CLIC Experimental Area Layout Design Considerations & ARUP Study

ARUP is a civil engineering consultant company that has been mandated by CLIC/ILC to perform the following study (splitted into task 1 & 2):

Task 2: Study the layout of the experimental cavern complex from a geotechnical standpoint, using the CLIC layout and CERN geology as reference model.

UX Cavern baseline.

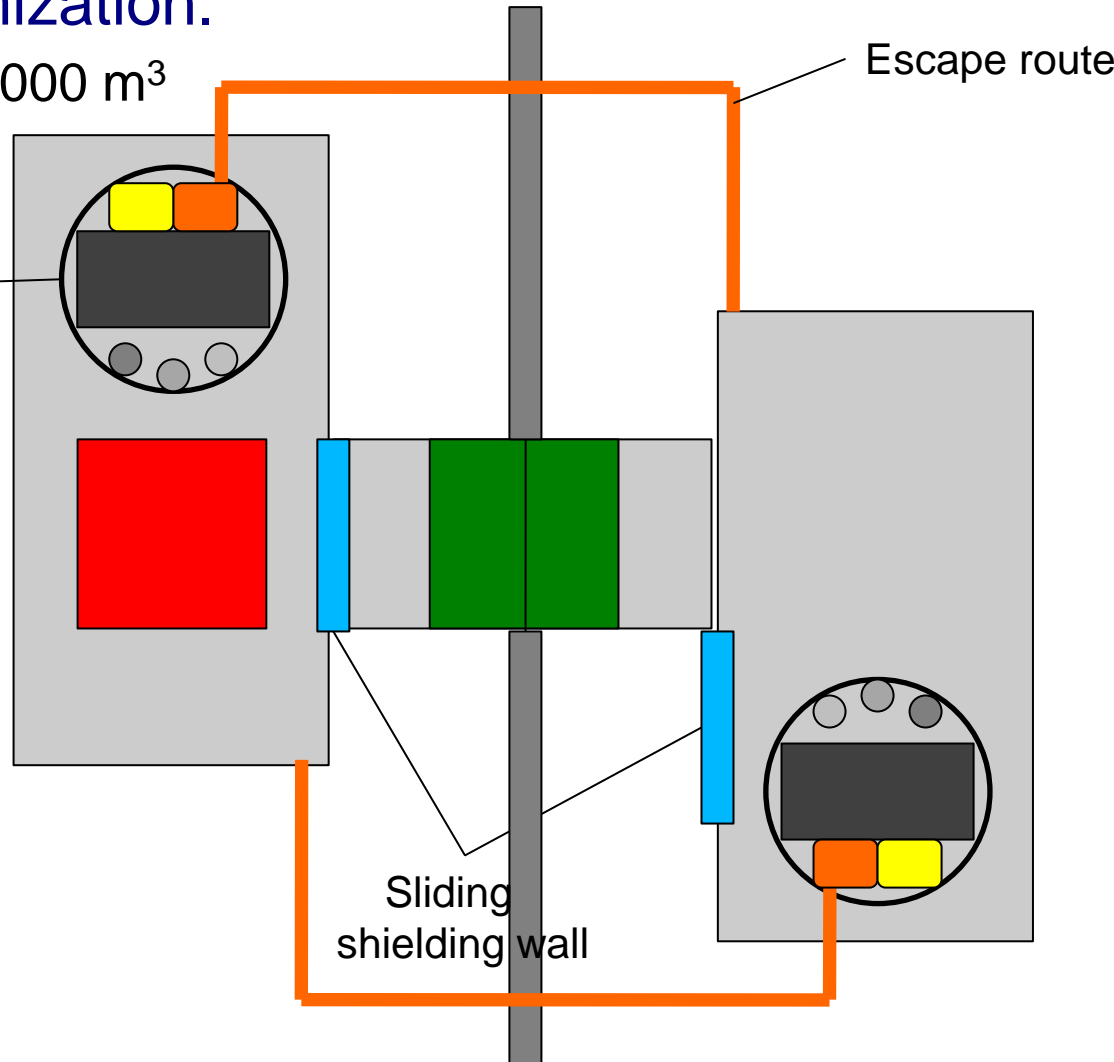
Cavern volume: 120,000 m³
2 x Φ 16m shafts

Easy to build

Asymmetric layout
Shaft on top of detector area
Shaft on the way of services
No escape route for detector B

UX Cavern optimization.

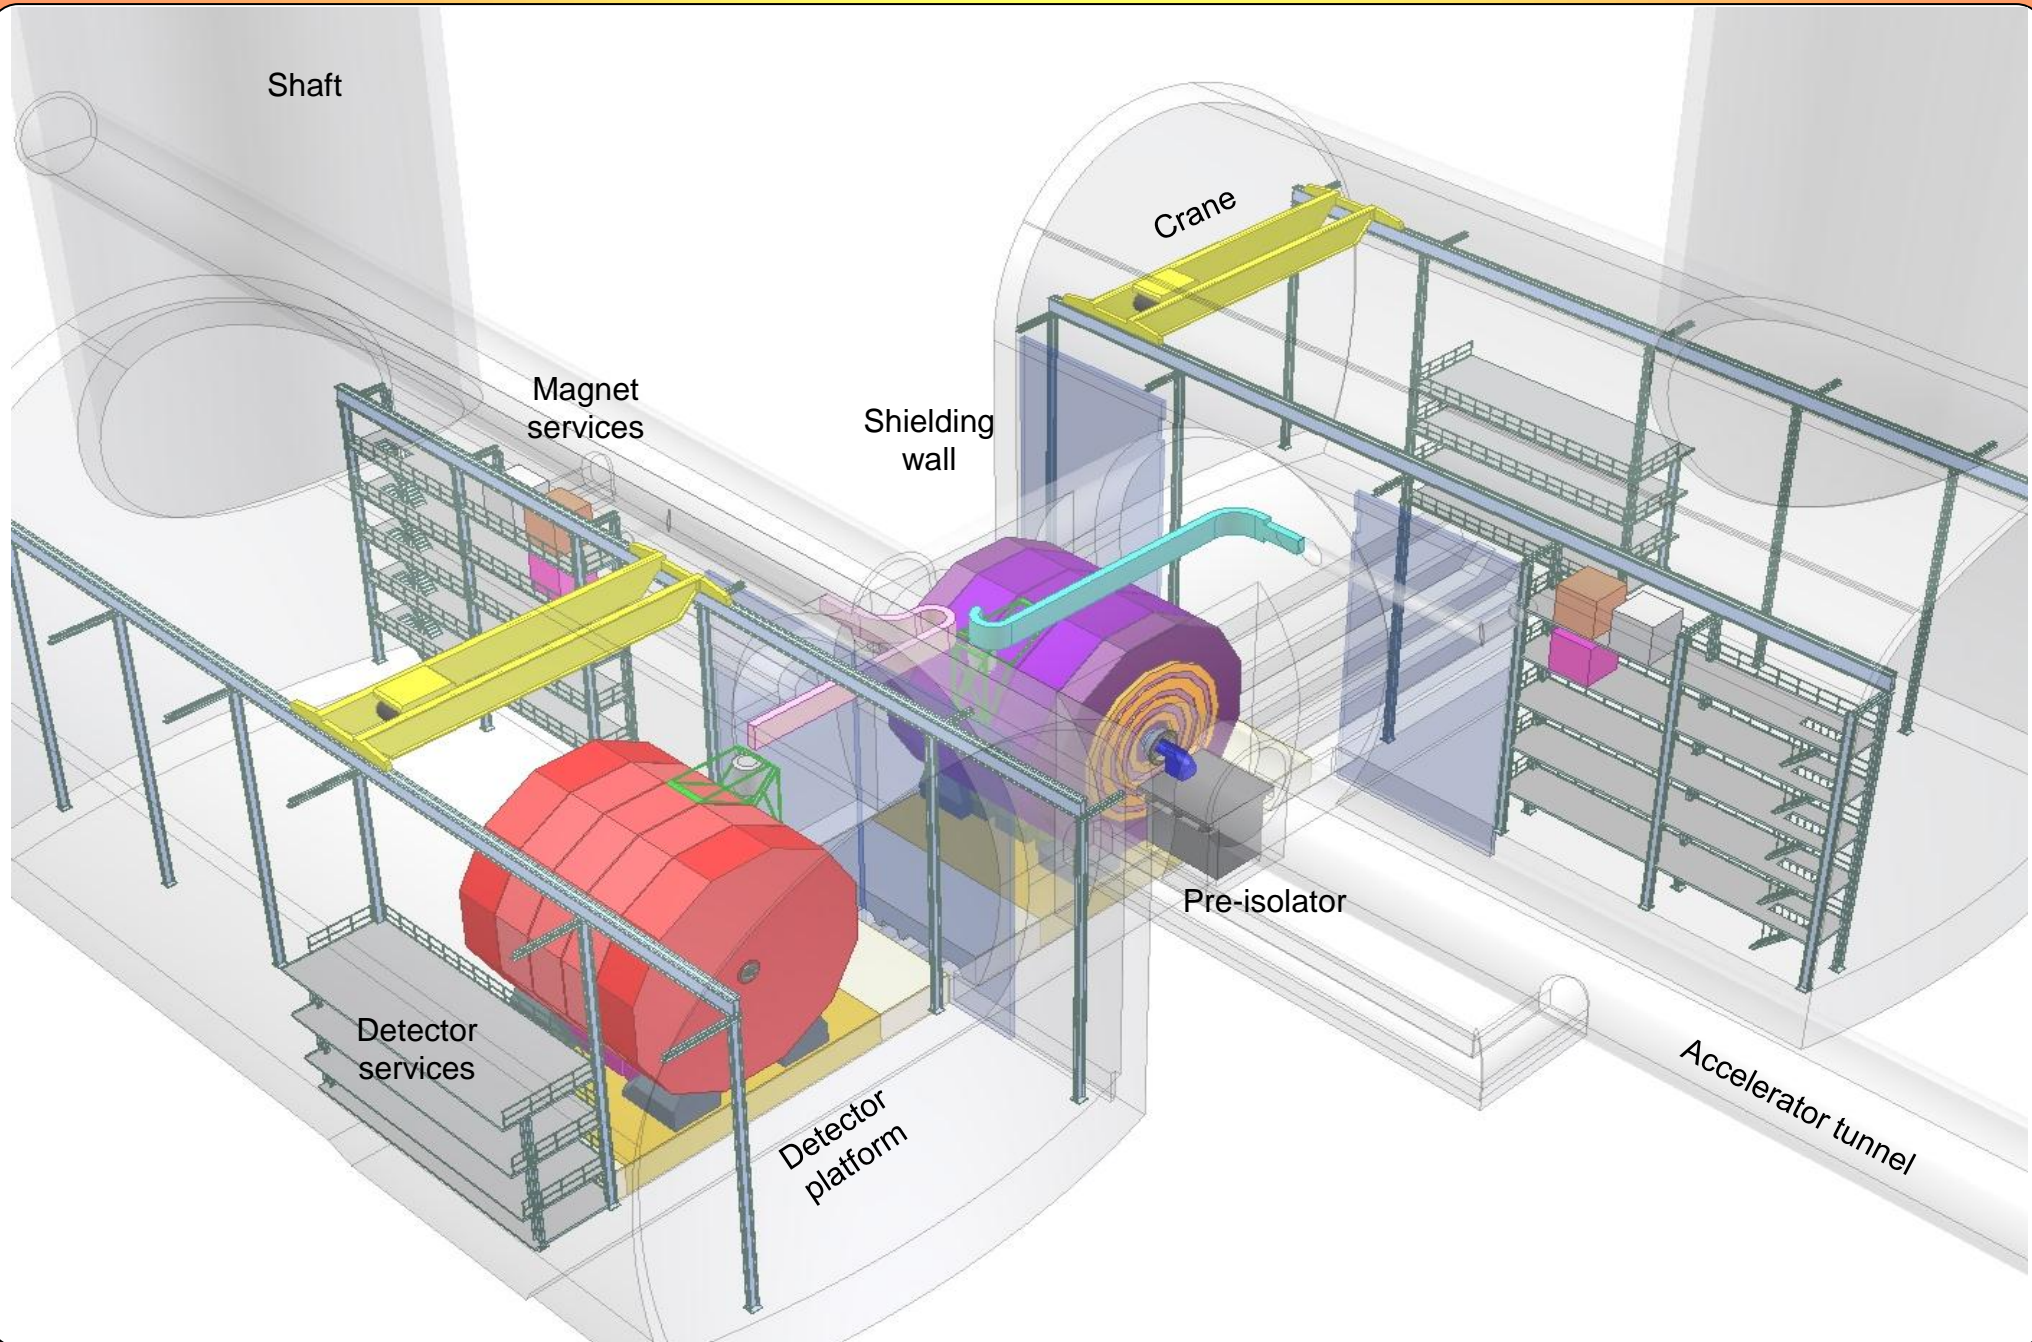
Cavern volume: 95,000 m³

Symmetric layout
Redundant escape routes
Easy shielding
Large assembly area

No detector opening when on-beam
Complex excavation

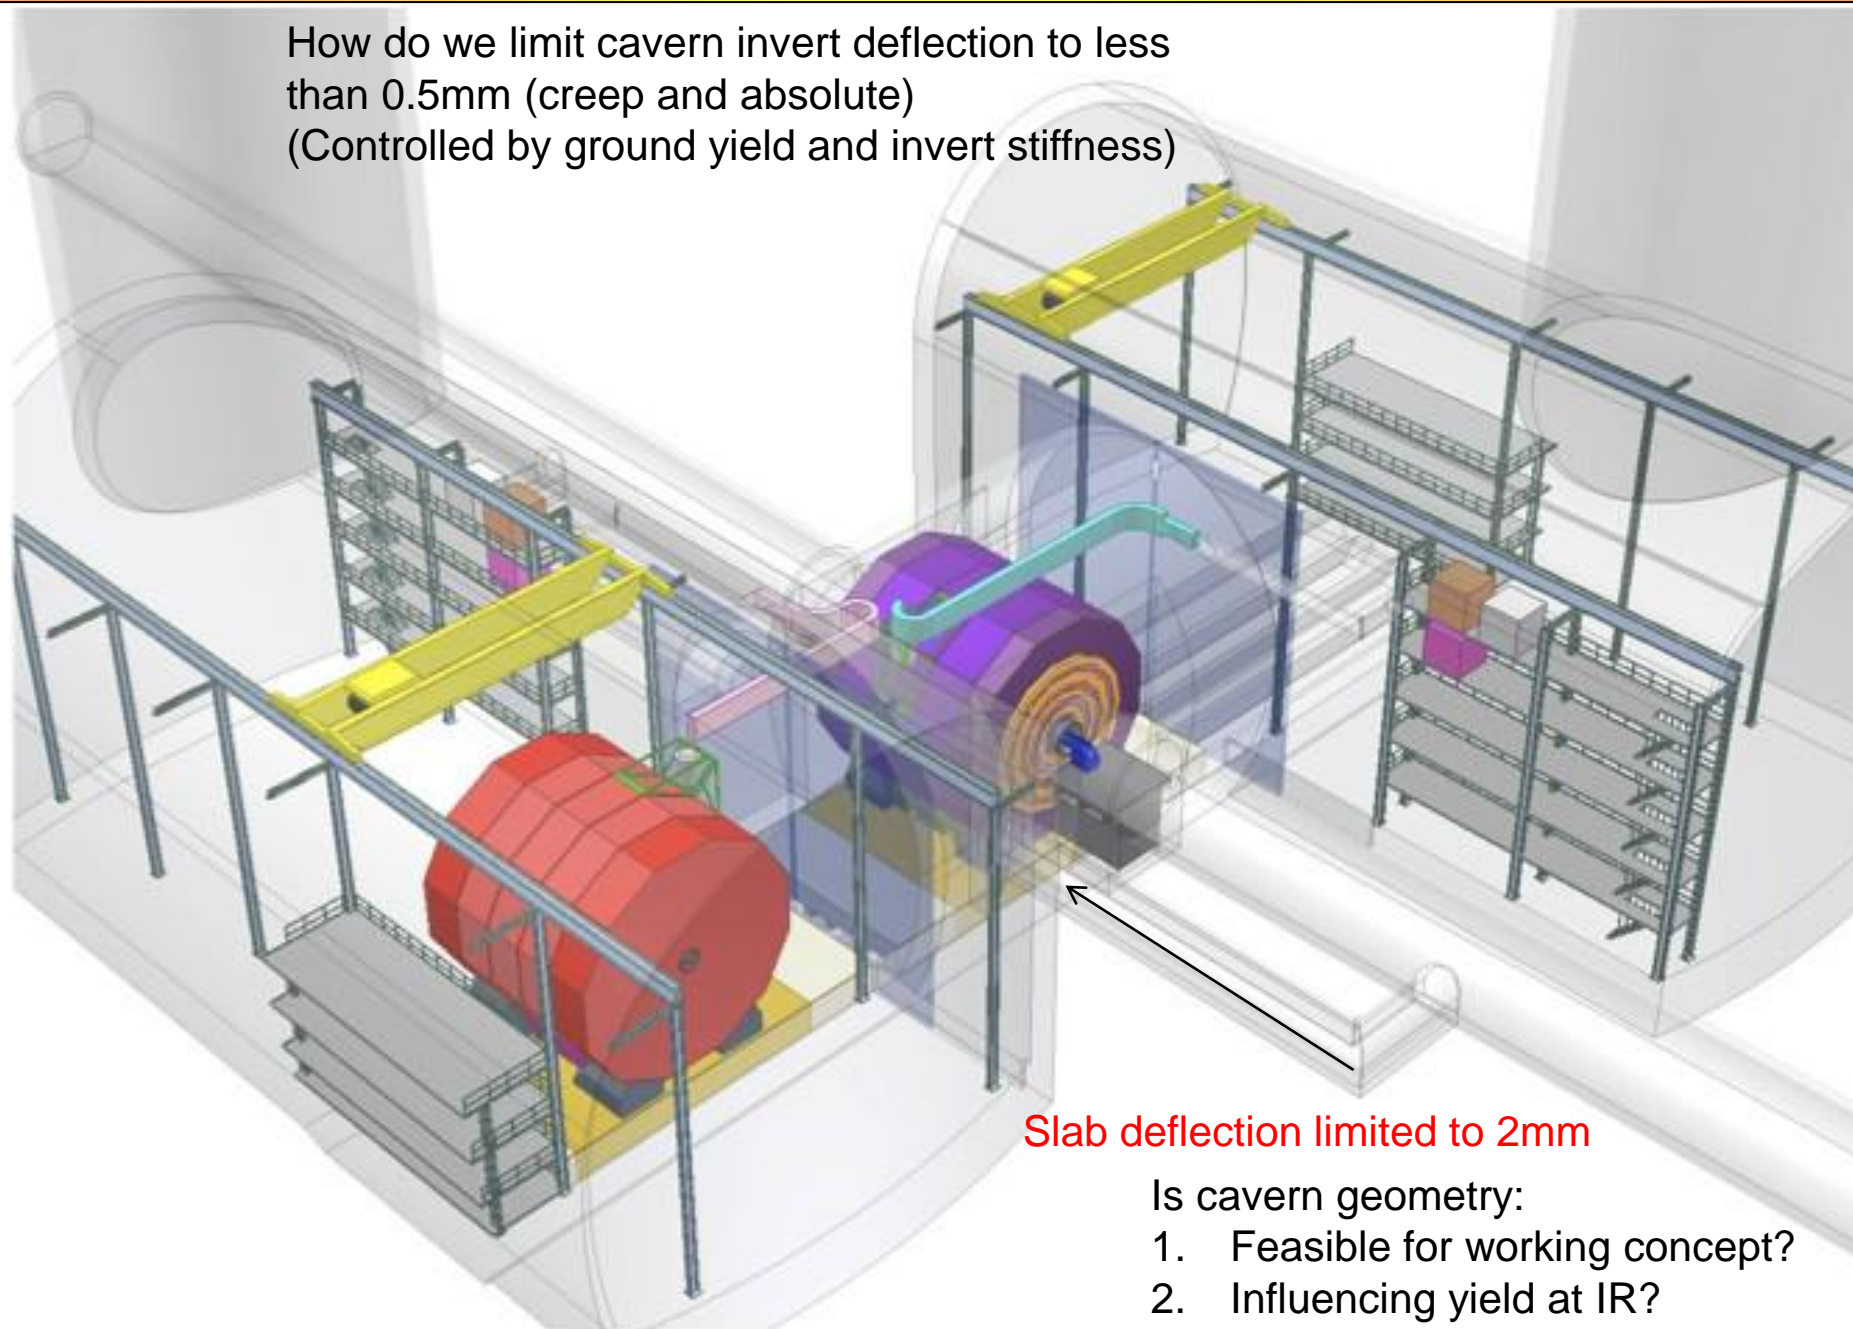
How do we limit cavern invert deflection to less than 0.5mm (creep and absolute)
(Controlled by ground yield and invert stiffness)

Slab deflection limited to 2mm

Is cavern geometry:

1. Feasible for working concept?
2. Influencing yield at IR?

Serviceability Limit State Analysis Invert Slab Deformed Shape

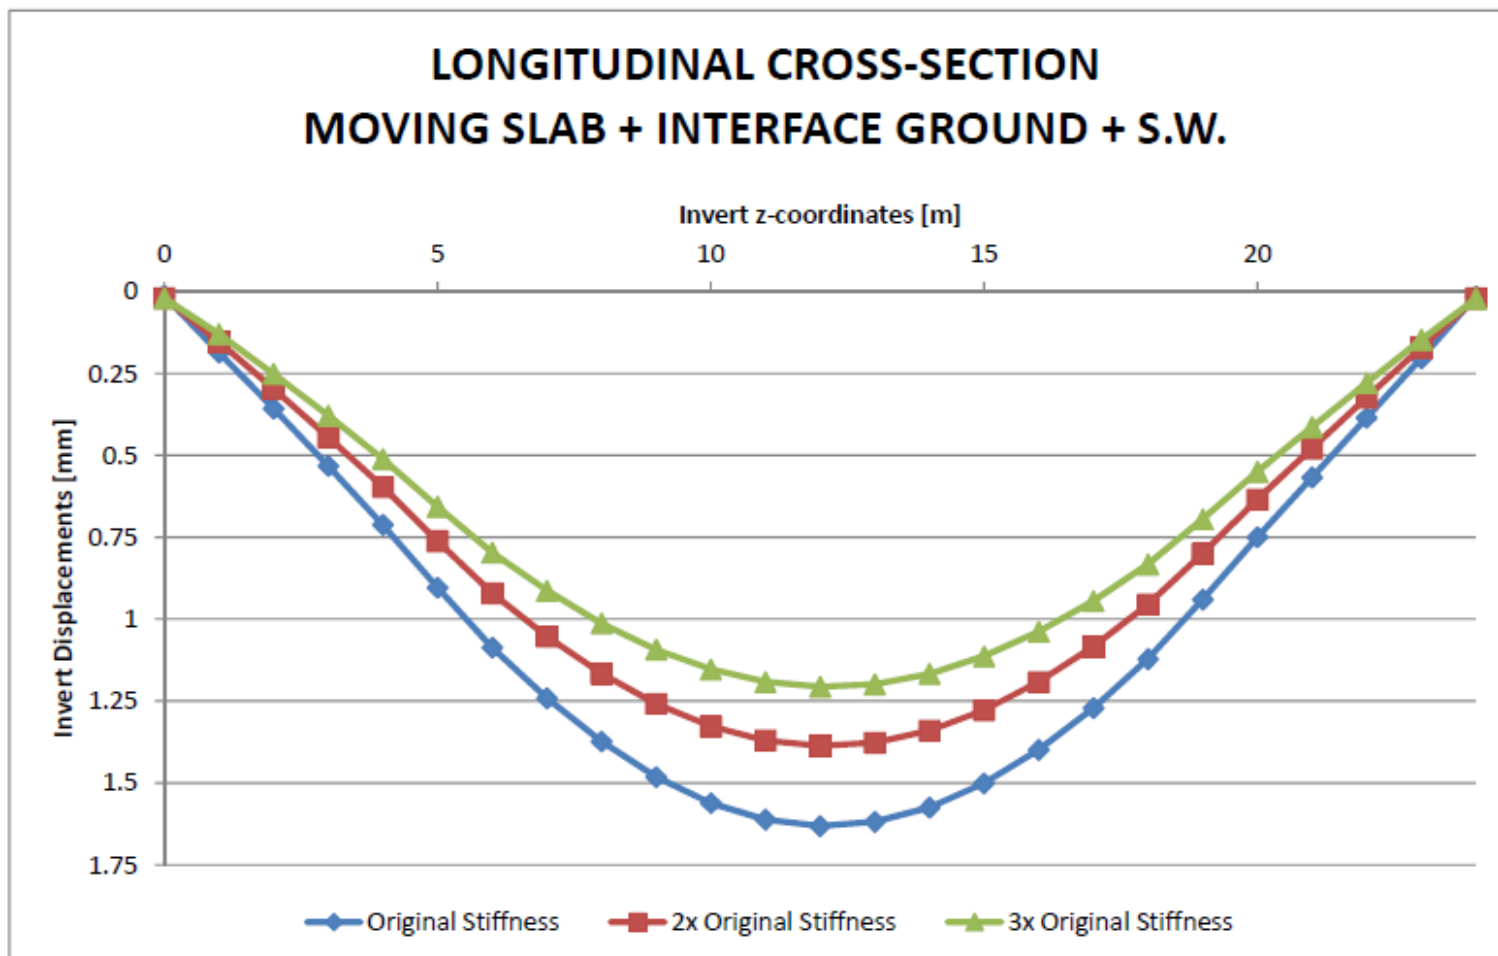
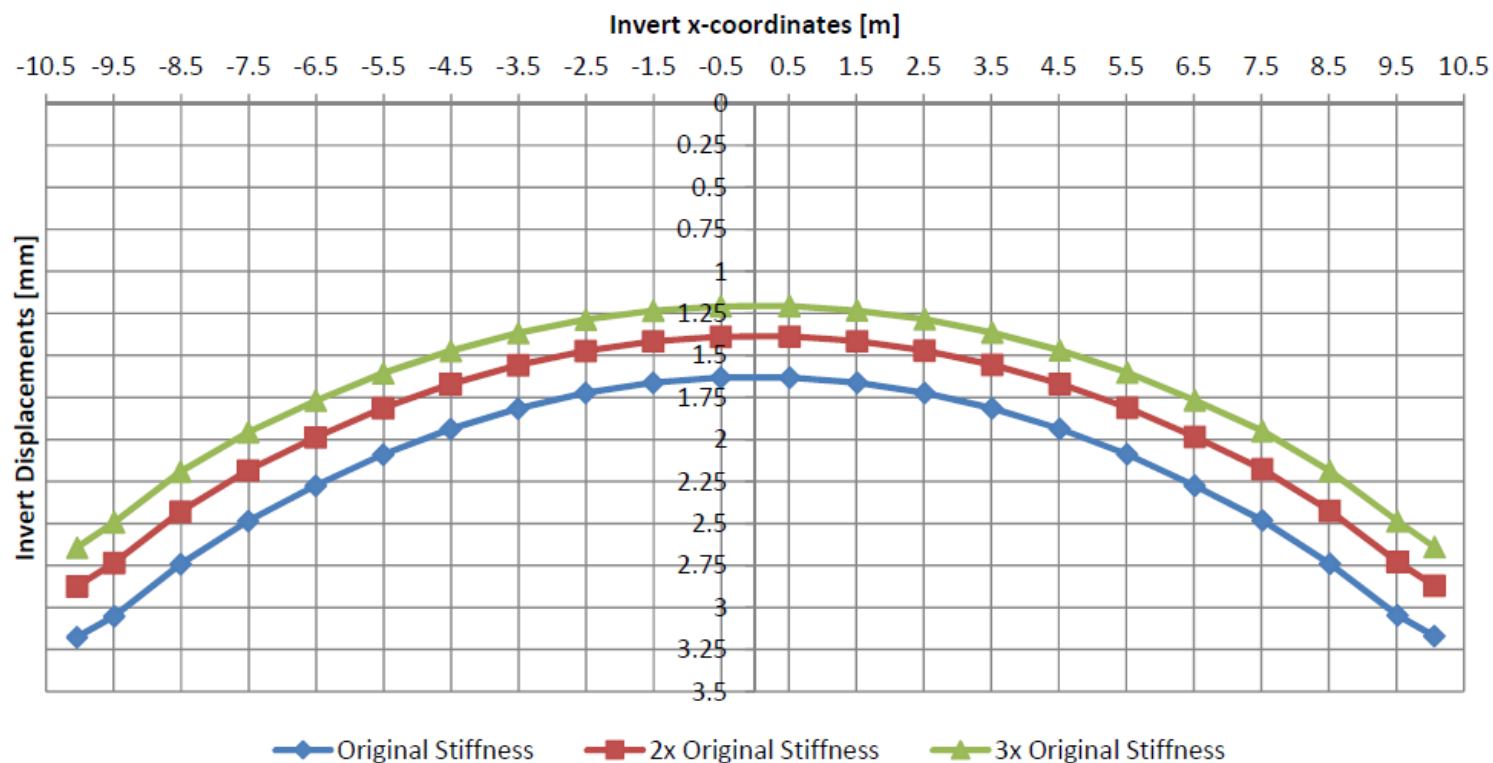
2D FE model stiffness	2x FE Stiffness	3x FE Stiffness
1.6 mm	1.4 mm	1.2 mm

1.55mm

1.5mm

1.44mm

Conclusions & Recommendations from Arup.

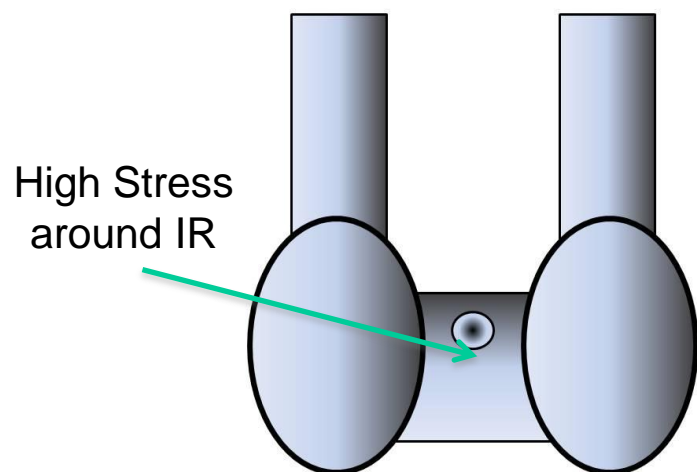
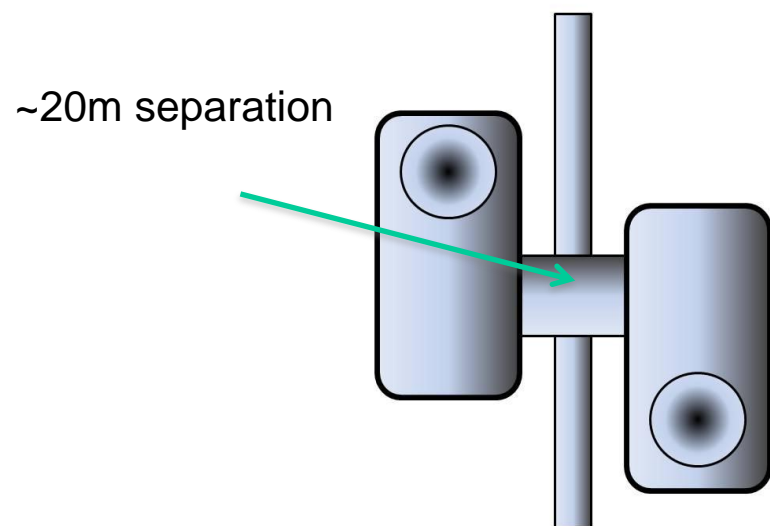
- Assuming a conservative model, invert static deformations exceed acceptable limits. This depends on extent of yielding around cavern during construction (i.e. EDZ⁽¹⁾).
- An appropriate construction sequence should limit this. Construction of shaft and interaction cavern prior to service caverns sequence would limit soil yielding at the invert.

However significant support (piling under invert and pre-stressing) will be required to assure the long term stability of the invert.
